**PLANNING COMMISSION AGENDA**

Tuesday, December 01, 2015  
Breckenridge Council Chambers  
150 Ski Hill Road

## Planning Commission Staff Report

Harris Street Side

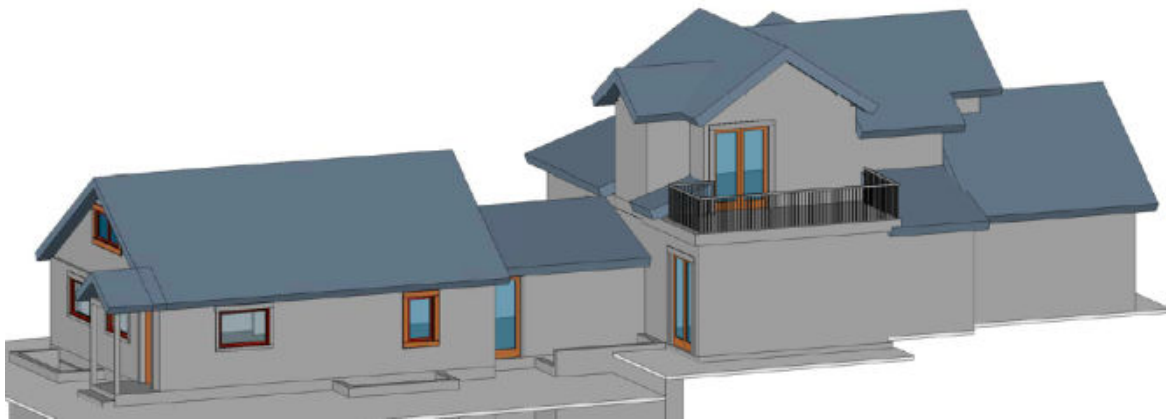
As the image below depicts, the taller mass of the addition has been pulled in off the alley edge reducing the visual massing along the alley. The views from Harris Street are buffered by the distance to the new addition (47-feet back to the addition) and by several mature cottonwood trees. Staff is supportive of the taller mass of the addition as it is buffered from the front and back property edges.

COMPOSITE EXTERIOR  
ELEVATIONS  
A302

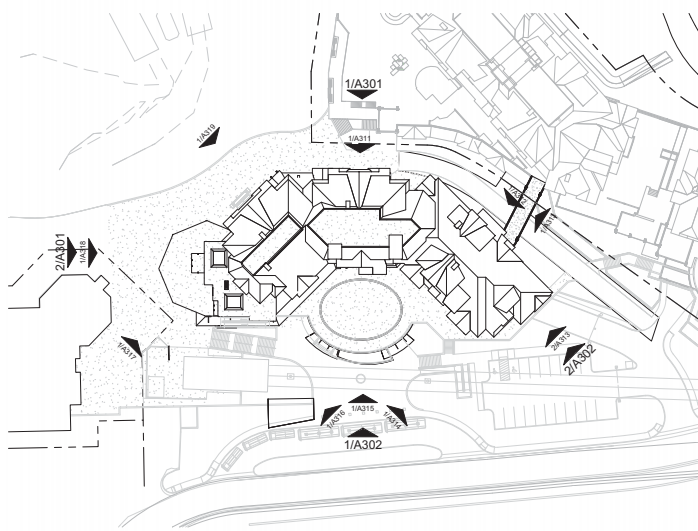
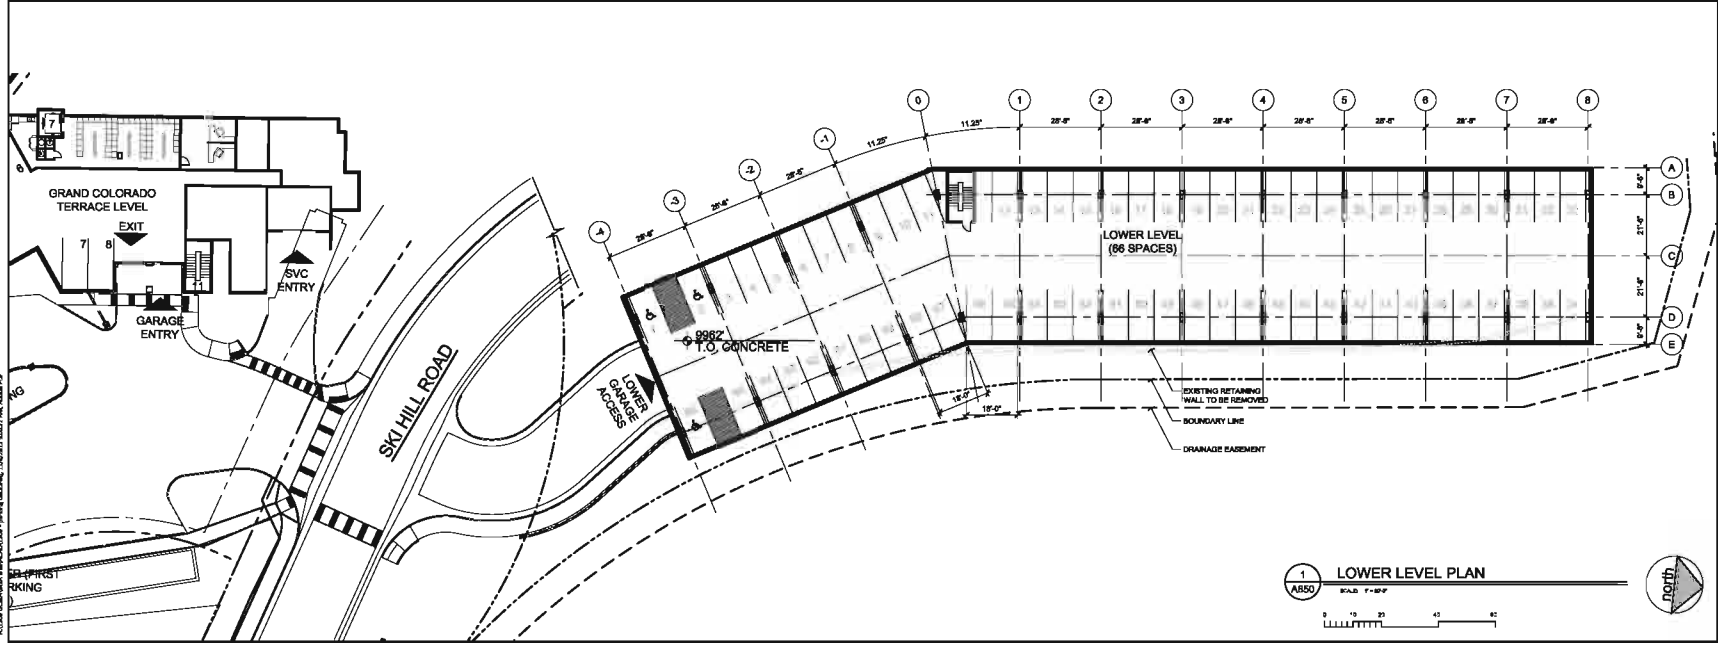
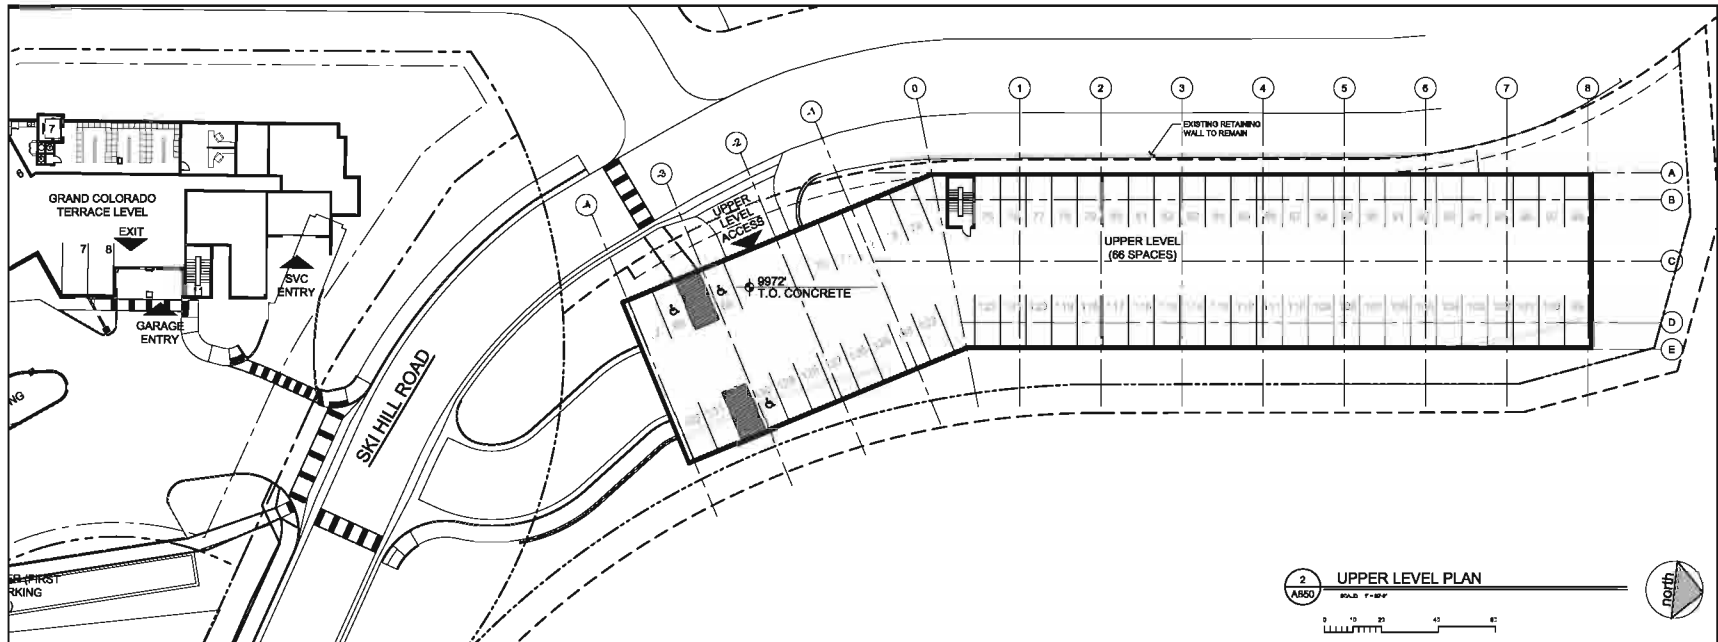
As proposed with the 6th Amendment of the Amended Peak 7&8 Master Plan,(PL-2015-0444) the use of natural stone on the buildings at the Base of Peak 7&8 has expanded from the use of authentic stone only on foundations to include chimneys and other accent elements. Natural stone is used at the foundation, for vertical accents/columns, and for the chimney/duct enclosures. (See sheets A301 and A302.)

The drawings show a series of terraced decks at the east end of the building and stepping roof forms at the west end of the building. The Composite East Elevation on Sheet A302 best illustrates these changes. Staff believes this change meets the intent of this policy although the decks are not "roof forms") and would suggest that the building provides broken, interesting roof forms that step down at the edges. We are showing negative ten (-10) points for the height overage and positive one (+1) point for placing density into the roof forms and positive one (+1) point for the building forms stepping down at the edges. Does the Commission agree?
